From: [Valeria Bentorkia-Moran](#)
To: [BOS Legislation, \(BOS\)](#)
Cc: [Emily Lowther Brough](#); tcatalano@reubenlaw.com
Subject: Re: File No. 250134 | Appeal of CEQA Determination (Exemption)
Date: Friday, April 4, 2025 1:42:47 PM
Attachments: [image001.png](#)
[2132 HOA Appeal ltr 4.4.25 w EXs.pdf](#)

Re: File No. 250134
Appeal of CEQA Determination (Exemption)
Proposed 2142 22nd Street Project (2024-005274PRJ)
Hearing: April 15, 2025 at 2:00 p.m.

GEOTECHNICAL INVESTIGATION

2142 22nd Street,
San Francisco, CA

Project site -
Slope is > 4H:1V

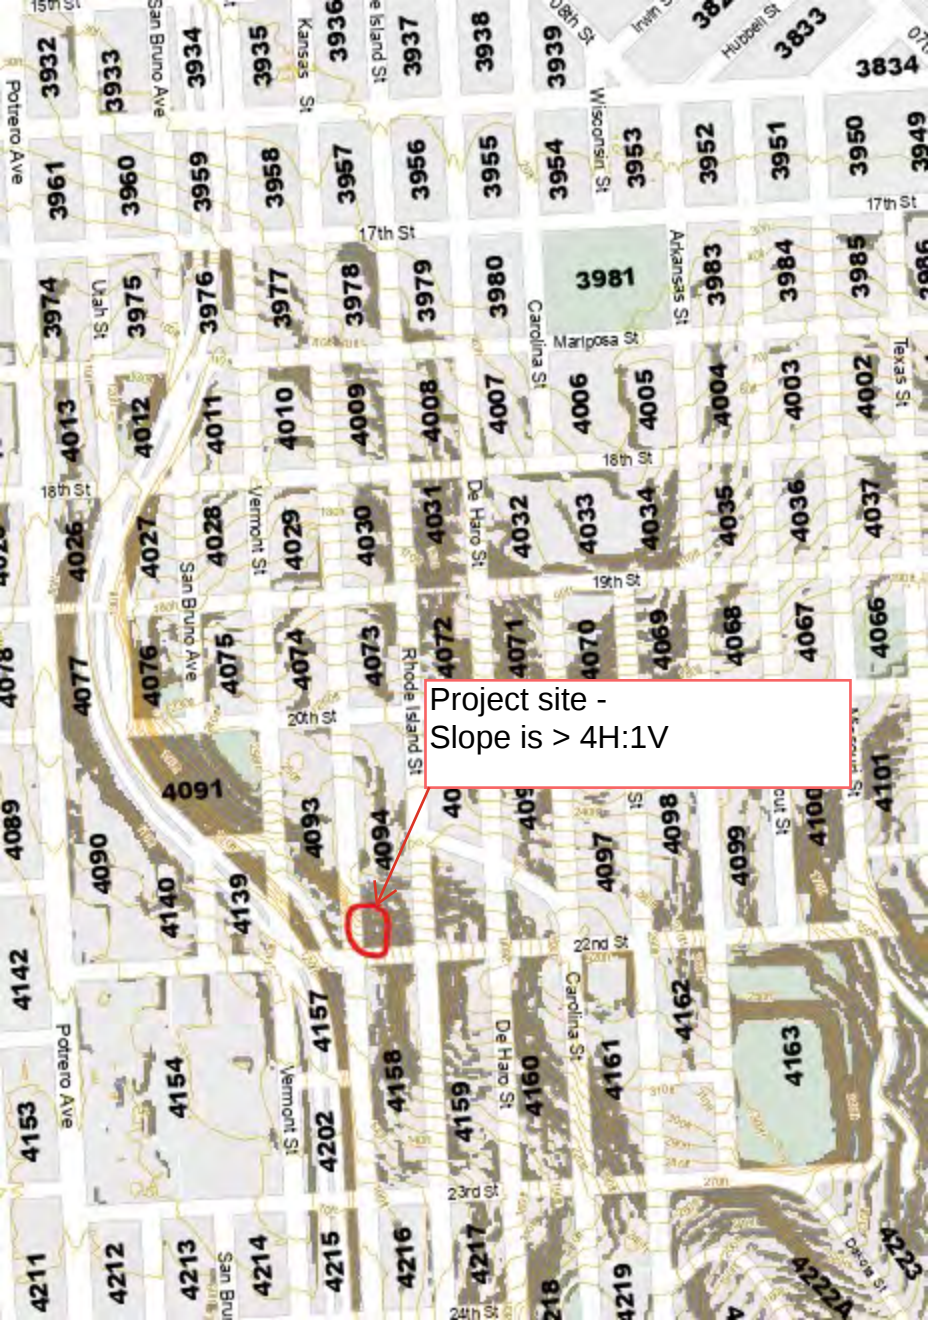
- (1) Exceeds an average slope of 4 horizontal to 1 vertical (4H:1V / 25%) and reaches over a 40% grade in some areas; (Topographic Map of San Francisco: 4H:1V Slope; also see **Exhibit A**, screenshot of Project site; **Exhibit B**, Project Report p. 6.)
- (2) Is located in the California Seismic Hazard “Liquefaction” Zone; (California Seismic Hazard Zone Map; also see **Exhibit C**, screenshot of Project site.)
- (3) Contains potentially asbestos-laden Serpentine Bedrock; (**Exhibit B**, Project Report p. 6, Fig 4) and
- (4) Contains a potentially Significant and/or Landmark Tree as defined by San Francisco Public Works. (**Exhibit D**; <https://sfpublicworks.org/services/significant-and-landmark-trees>.)
